Buffalo River Watershed Alliance

Comments on C&H Reg 5 Permit Application

Appendix C13 Evidence of perched groundwater.

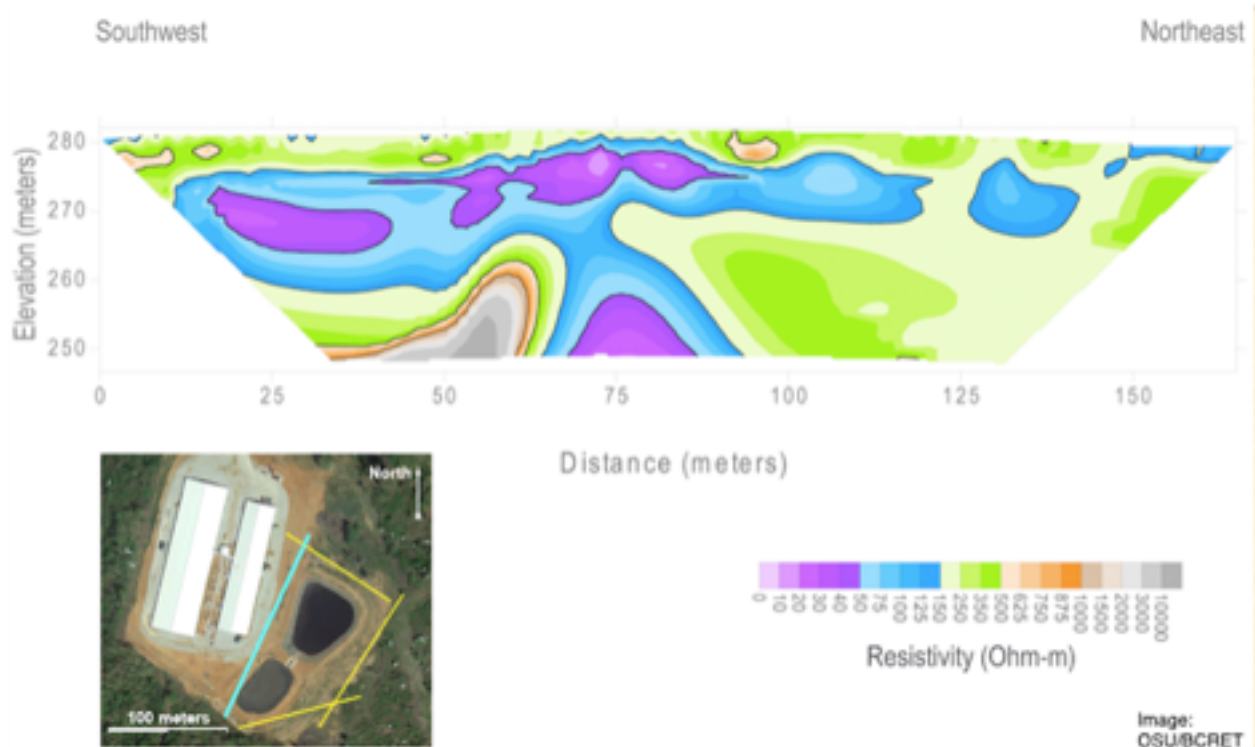
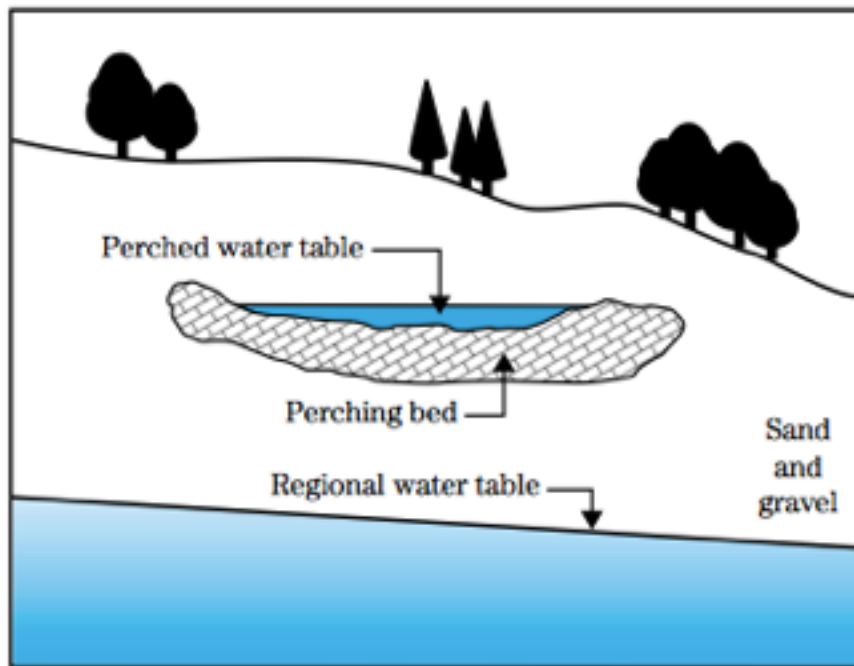
“A perched aquifer (fig. 7–8) is a local zone of unconfined groundwater occurring at some level above the regional water table, with unsaturated conditions existing above and below it. They form where downward-percolating groundwater is blocked by a zone of lesser permeability and accumulates above it. This lower confining unit is called a perching bed, and they commonly occur where clay lenses are present, particularly in glacial outwash and till. These perched aquifers are generally of limited lateral extent and may not provide a long-lasting source of water. Perched aquifers can also cause problems in construction dewatering and need to be identified during the site investigation.”
